Sydney Children's Hospital Stage 1 and Children's Comprehensive Cancer Centre

State Significant Development Architectural Report _Addendum
SSD Application - 10831778

SCH-AR-RT-DA058A[A]

September 2021

Figure 10 General Arrangement Plan - Level B1 south

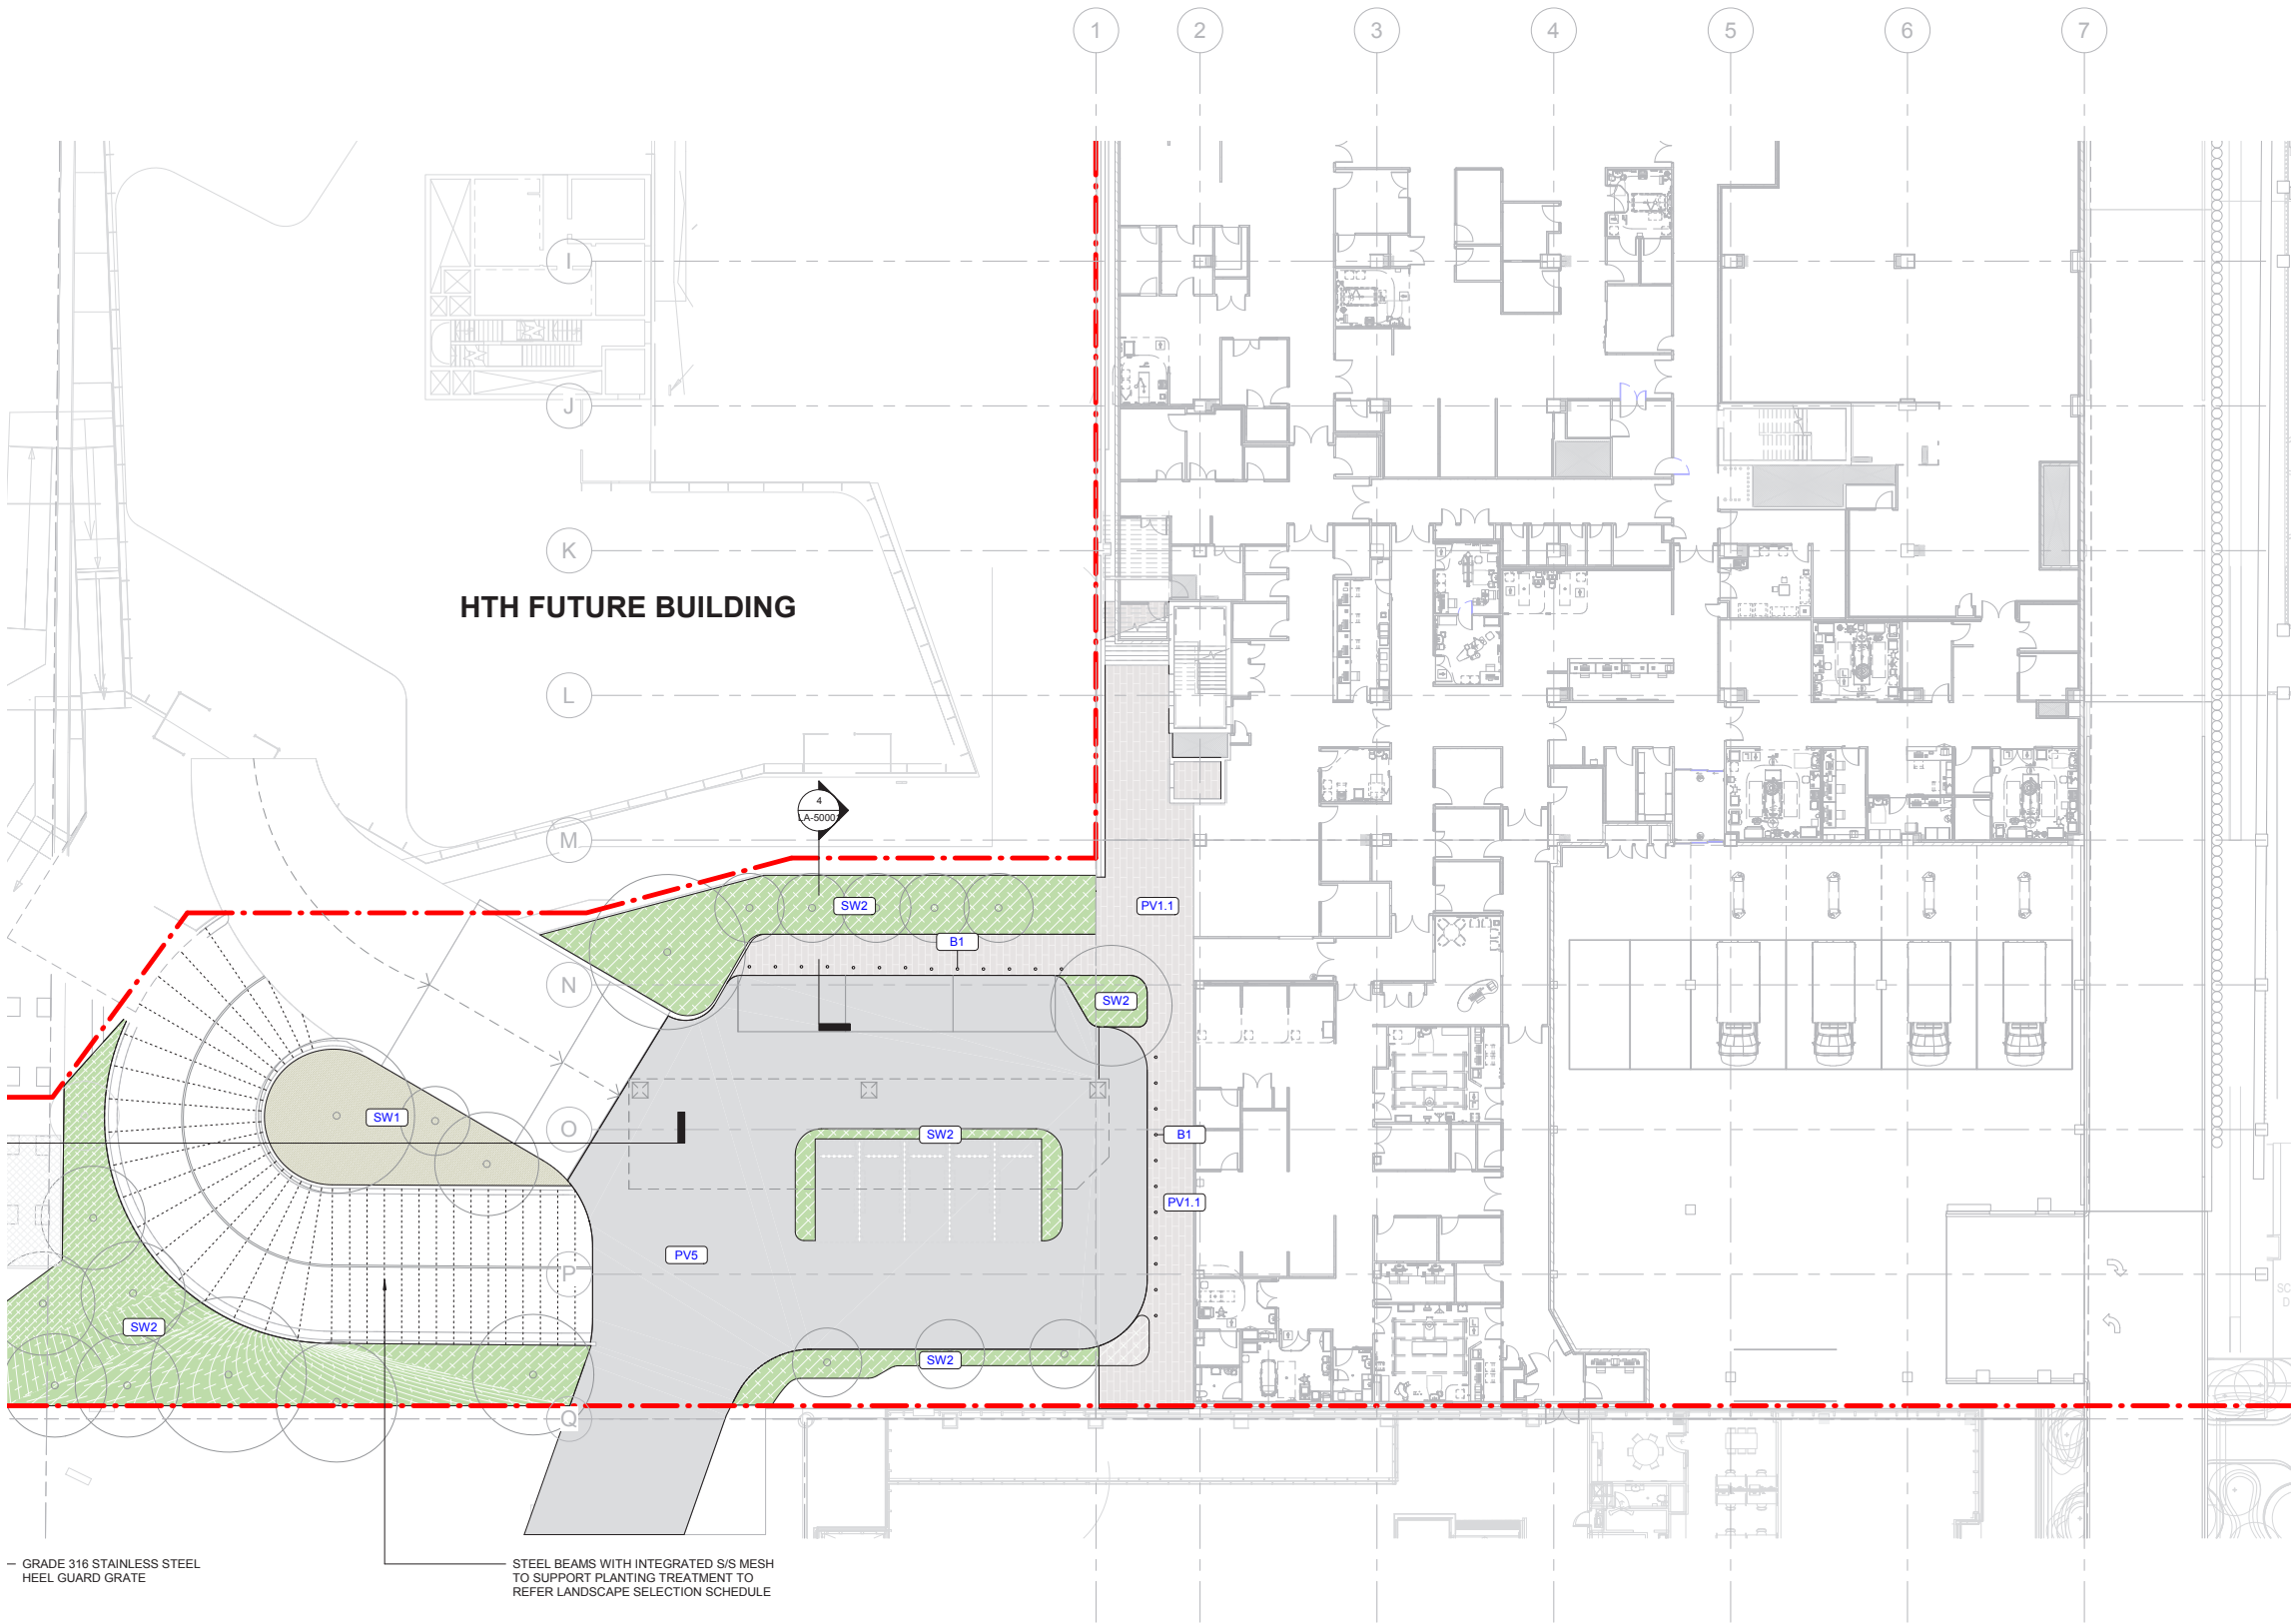
SUBMISSION COMMENT/ AGENCY	RESPONSE
Emergency Department - Vehicle Access and drop-off/pickup	
<p>The proposed Botany Street drop off to the emergency department is characterised by blank walls, significant hard paved areas and narrow paved footpaths and waiting areas. Further, it is unclear how visitors and patients arriving by car can easily and intuitively understand the direction to take to the reception, triage and waiting area. Council questions why the IASB Satellite Imaging facility is located at the emergency drop off.</p>	<p>Functional adjacencies have required the Emergency Department to be located on Level B1. Competing requirements for access to not only the Emergency Department, but also the IASB and the HTH have all been considered in the design of this shared vehicular entry and drop off point.</p> <p>The design of the Emergency Department itself is based on required functional adjacencies and workflows and ensures a clear arrival point and clear and direct access to Triage as a key functional priority. Refer to drawing SCH1-AR-DG-SSD011.</p> <p>BLP have provided updated additional renders demonstrating clear access and amenity to the Emergency Department reception. Refer to page 34 of this report.</p> <p>Detailed Wayfinding and Signage will be undertaken as part of future work package and will be developed to ensure clear, direct, and intuitive access.</p>

<p>A further concern is the significant overshadowing of this arrival area throughout the year and particularly in winter. This contrasts with the current sunny north facing High Street entry. Additional information and detailing is required to demonstrate how this waiting space will be treated to provide a warm and inviting arrival experience and safe waiting area for parents and children, given the constraints outlined above.</p>	<p>Functional adjacencies have required the Emergency Department to be located on Level B1, with access provided via the Botany Street entry.</p> <p>Competing requirements for access to not only the Emergency Department, but also the IASB and the HTH have all been considered in the design of this shared vehicular entry and drop off point.</p> <p>The design of the Emergency Department itself is based on required functional adjacencies and workflows and ensures a clear arrival point and clear and direct access to Triage as a key functional priority.</p> <p>BLP have provided updated additional renders demonstrating clear access and amenity to the Emergency Department reception. Refer to Appendix A of this report</p> <p>Internally, opportunities for integration of public art will be investigated.</p> <p>Refer to architectural drawings, for additional internal detail of Emergency Department.</p> <p>Refer to architectural drawings SCH1-AR-DG-SDD040, SCH1-AR-DG-SDD041, SCH1-AR-DG-SDD042 and SCH1-AR-DG-SDD043.</p>

Emergency Department - ED Location	
<p>Council questions the location of the children's emergency department underground in a location with no real outlook and only token access to natural light and sunshine.</p>	<p>Functional adjacencies have required the Emergency Department to be located on Level B1, with access provided via the Botany Street entry.</p> <p>Competing requirements for access to not only the Emergency Department, but also the IASB and the HTH have all been considered in the design of this shared vehicular entry and drop off point.</p> <p>The design of the Emergency Department itself is based on required functional adjacencies and workflows and ensures a clear arrival point and clear and direct access to Triage as a key functional priority.</p> <p>BLP have provided updated additional renders demonstrating clear access and amenity to the Emergency Department reception. Refer to Appendix A of this report</p> <p>Refer to architectural drawings, for additional internal detail of Emergency Department</p>

The entry to the Emergency Department is characterised by colour back glass panels to provide interest and warmth to the façade in this location and to tie in with the wetlands narrative of connected to the ground plane. The design of the Emergency drop-off canopy shares a similar structural expression and material treatment to that of the High Street canopy (not part of this application) thus providing clear definition as an additional entry point of the Hospital.

Figure 14 Typical Plan - Sunshades unfolding from the panel

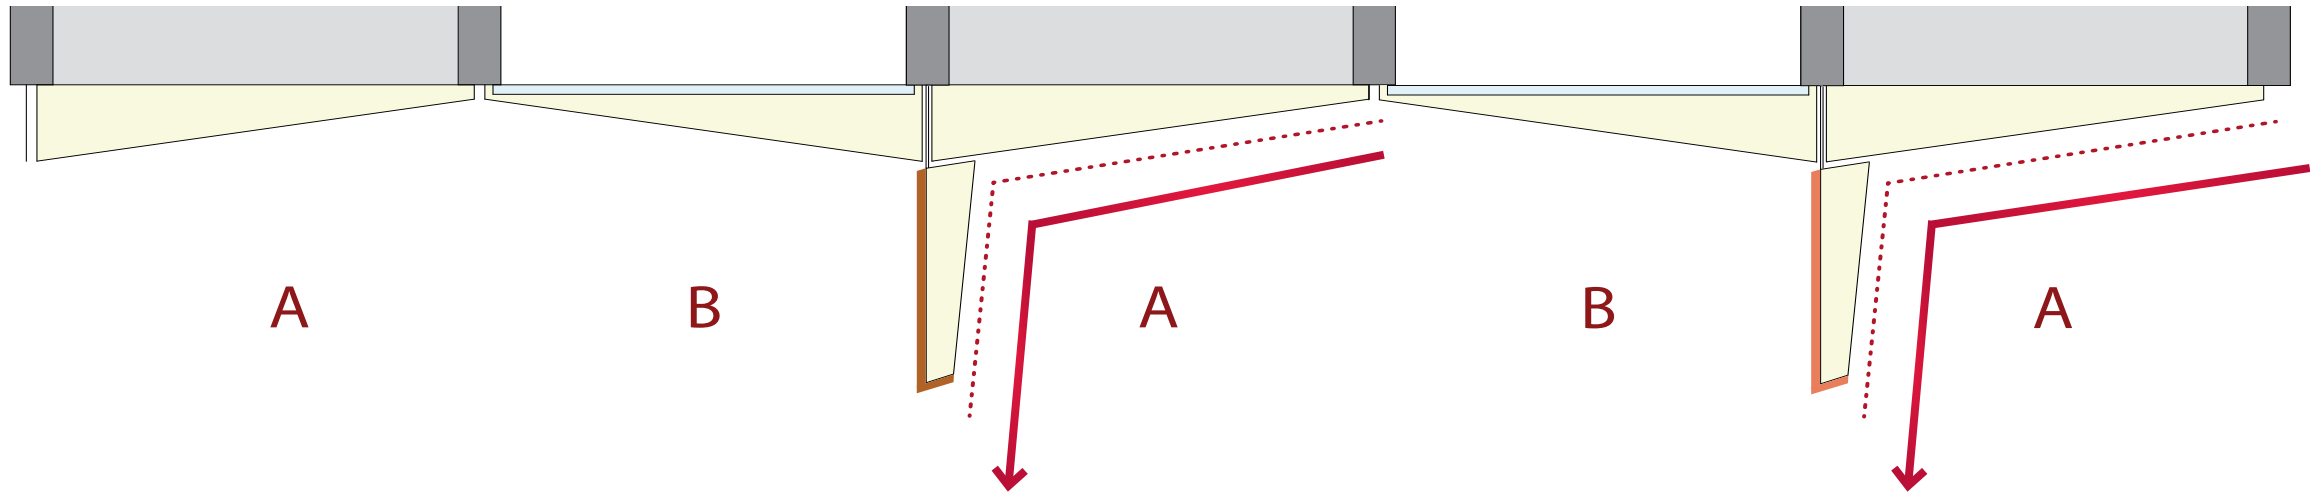
Sun Shading Devices		
<p>The building sun shading devices should respond to the solar conditions that vary according to the building's orientation. Windows that face north are generally best shaded with horizontal overhangs (or blades), south facing windows may not need any shading, west and east facing windows generally are best shaded, as illustrated, with vertical blades that protect windows when the sun is low in the sky. This overlay of variety across the various building elevations would help to mitigate repetitive expression of panels and windows</p>		<p>Further modelling work has been undertaken to help determine the location of sunshading, which is appropriate to the building uses within. Sunshading elements have been removed from the southern façade. Sunshading elements to the northern façade incorporate horizontal elements.</p> <p>Refer to Sections 3,4 and 6 for amendments that form part of this of addendum to the SSDA Architectural Report. Refer to updated architectural drawings.</p>

GANSW COMMENT	RESPONSE / REFERENCE SECTION
1.7	The scale of the ‘folded’ façade panels needs to be developed to create the desired ‘ripple effect’ referencing the play of light and shadow. The sun shading blades junction with the folded façade is not resolved. Consider these two elements as a singular system or two clearly distinct components.	<ul style="list-style-type: none"> — Currently undertaking prototyping. — Panel design (shape and configuration) has been refined to maximise the play of light and shade; to breakdown the scale of the built form (east); and to add textural accent to areas where the form changes (upper levels north and south) — The sunshades shape has been refined (as per above) but also to appear to ‘fold out’ of the building panels

The sunshading devices' profiling are also integrated with the façade on which they are located - sunshades located along the folded metal façades have an angular profile, designed to appear to fold out from the rippling façade; the flat colour back glass façades have simpler rectilinear profiled sunshades.
